**Re: Christina Lake Thermal Project Phase H and Eastern Expansion
Project Update and Supplemental Information Request 2 Responses
AER Application No. 1758947
EPEA Application No. 019-48522**

The purpose of this document is to provide responses to the Round 2 SIR package and provide updated information regarding the Project (Project Update). This document is organized into two parts as follows:

I:\CLIENTS\CENOVUS\14-1346-0011\mapping\MXD\C&R\SIR_Round2\ESRD_SIR_17_Figure_37_5.mxd

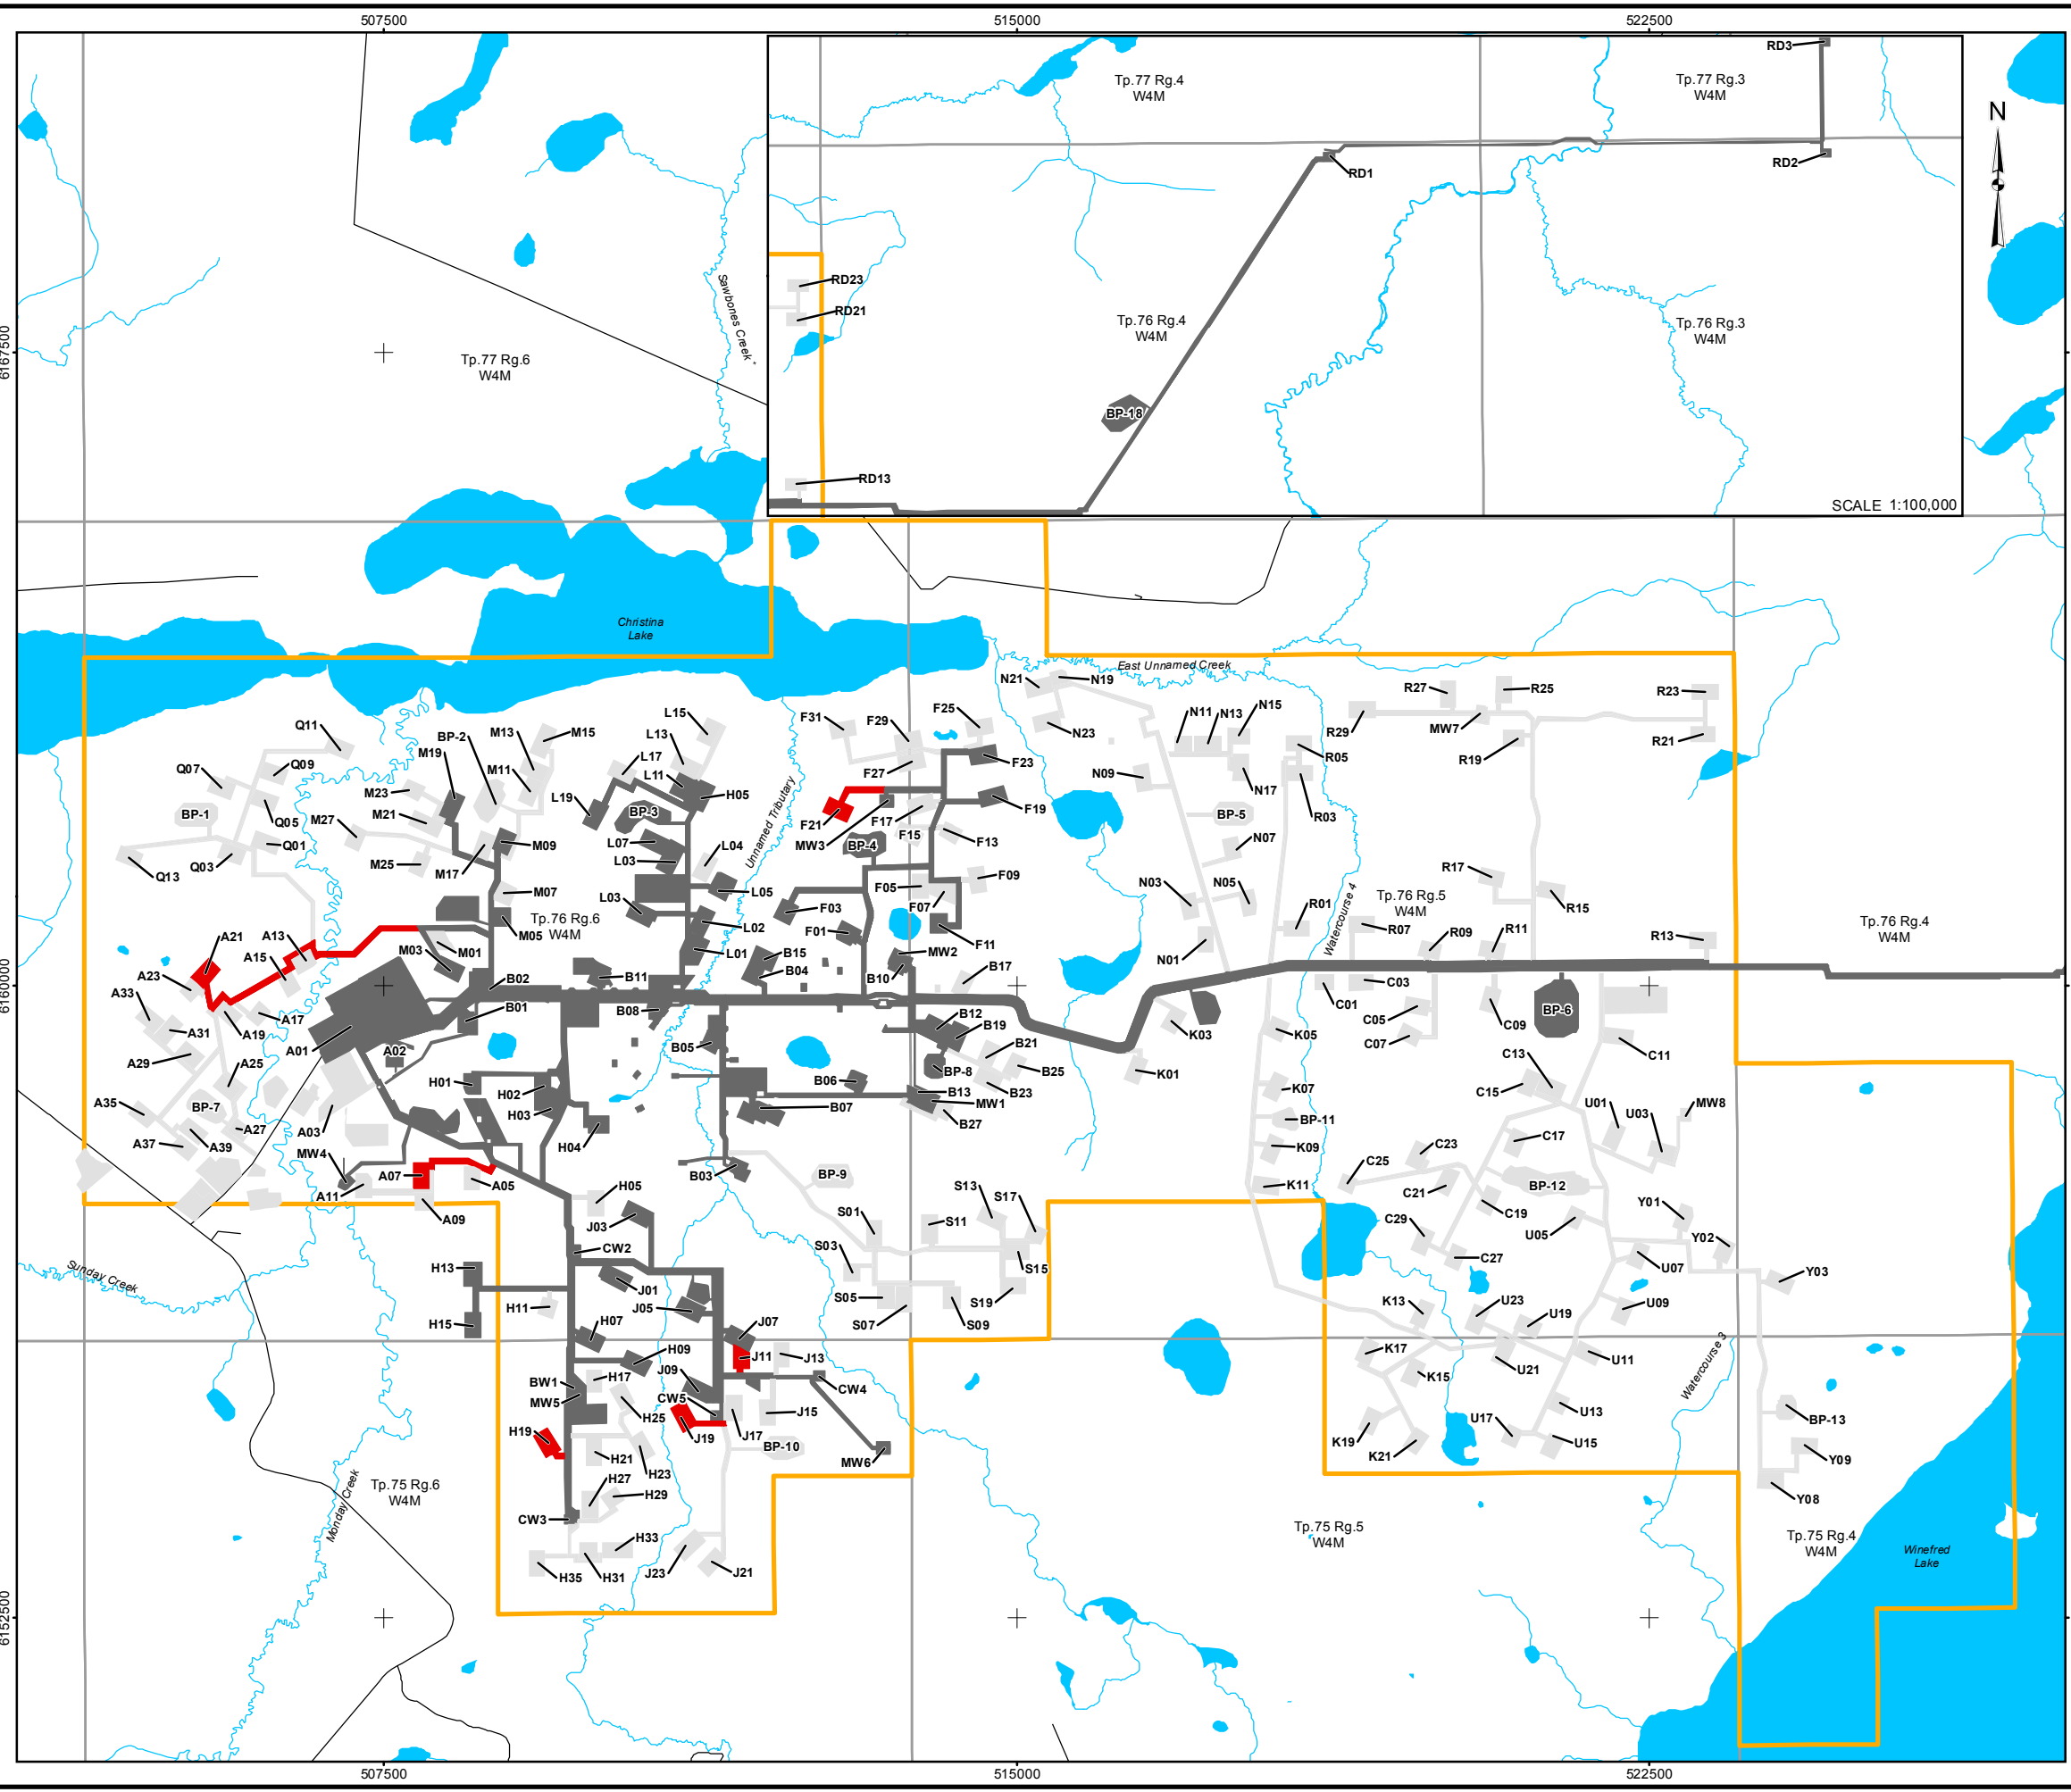
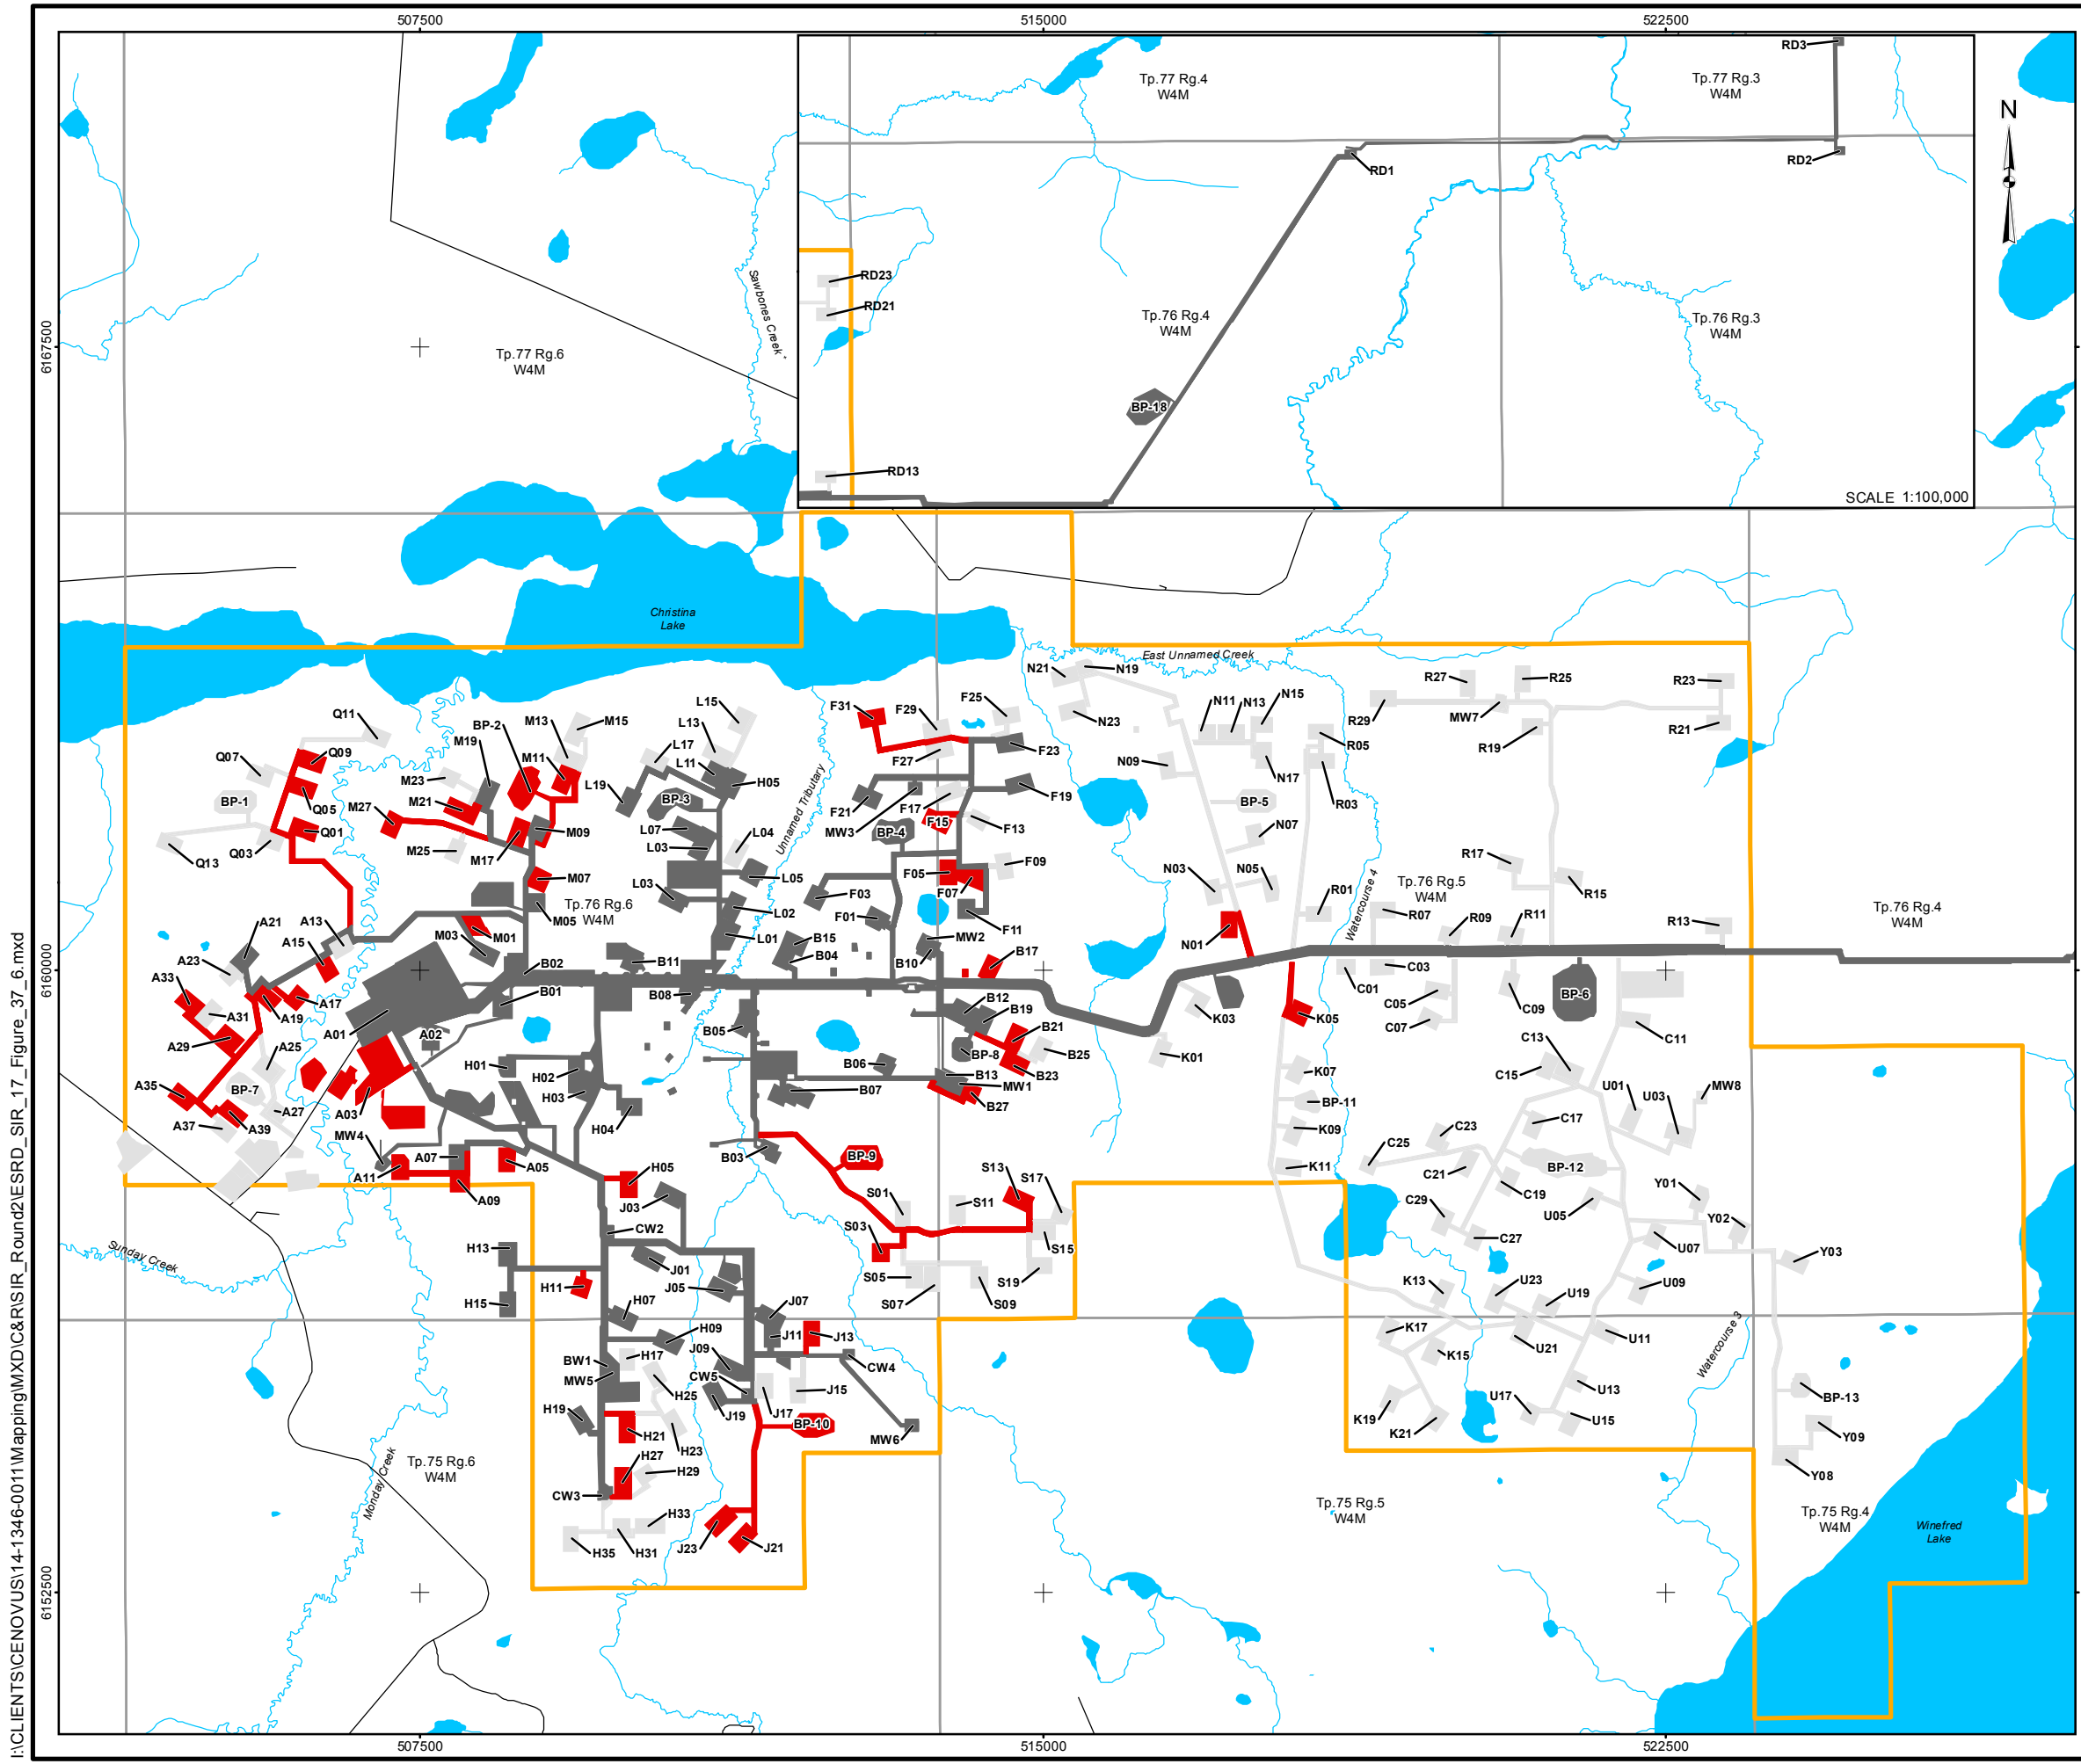
In Table 65-2, the column Unnamed (Monday) Creek appears to be mislabelled. All Figures in the SIR response 69 are mislabelled. In Figure 186-1, the sub-watershed is mislabelled.

Figures 69-1 to 69-13 from ESRD Round 1 SIR 69 have been revised and are presented as [Figures 37-1 to 37-13](#).
